Project	IEEE 802.16 Broadband Wireless Access Working Group http://ieee802.org/16 >
Title	Ambiguity in PHY layer §8.3 OFDM frequency and timing requirements
Date Submitted	2005-03-16
Source(s)	Juergen Otterbach Joerg Schaepperle Roland Muenzner Torsten Fahldieck Alcatel SEL AG Voice: +49-711-821-32255 Fax: +49-711-821-32453 Juergen.Otterbach@alcatel.de
Re:	Response to call for comments IEEE P802.16-2004/Cor1-D1
Abstract	Correction of inconsistencies for 802.16-2004 PHY §8.3 OFDM
Purpose	Resolving ambiguity in PHY layer §8.3 OFDM
Notice	This document has been prepared to assist IEEE 802.16. It is offered as a basis for discussion and is not binding on the contributing individual(s) or organization(s). The material in this document is subject to change in form and content after further study. The contributor(s) reserve(s) the right to add, amend or withdraw material contained herein.
Release	The contributor grants a free, irrevocable license to the IEEE to incorporate material contained in this contribution, and any modifications thereof, in the creation of an IEEE Standards publication; to copyright in the IEEE's name any IEEE Standards publication even though it may include portion

Figure 1: Possible differences in OFDM symbol duration

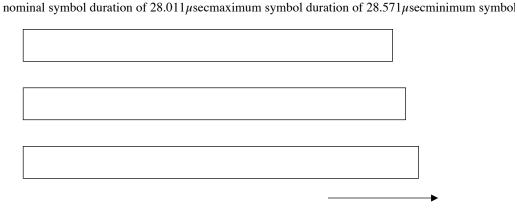
According to this tolerance the SS is allowed to transmit OFDM symbols with differences in duration as shown in Figure 1 with a Cyclic Prefix (CP) time of 1/4 of the "useful" symbol time assumed. The symbol time extension by the CP is 256/4 = 64 samples. The whole symbol is equivalent to 320 samples that correspond to symbol time $T_s = 28.011\mu$ sec nominal.

In a view of the Base Station receiver a nominal symbol duration of 28.011 μ sec is expected. An UL OFDM symbol with maximum symbol duration of 28.571 μ sec is 6.4 samples longer than the expected nominal symbol duration of 28.011 μ sec. A detection of the short preamble using time domain correlator principles would fail.

At the SS, both the transmitted center frequency and the symbol clock frequency shall be synchronized and locked to the BS with a tolerance of maximum 2% of the subcarrier spacing and the sampling frequency of the SS shall be synchronized to the sampling frequency of the BS with a tolerance of ±5ppm.
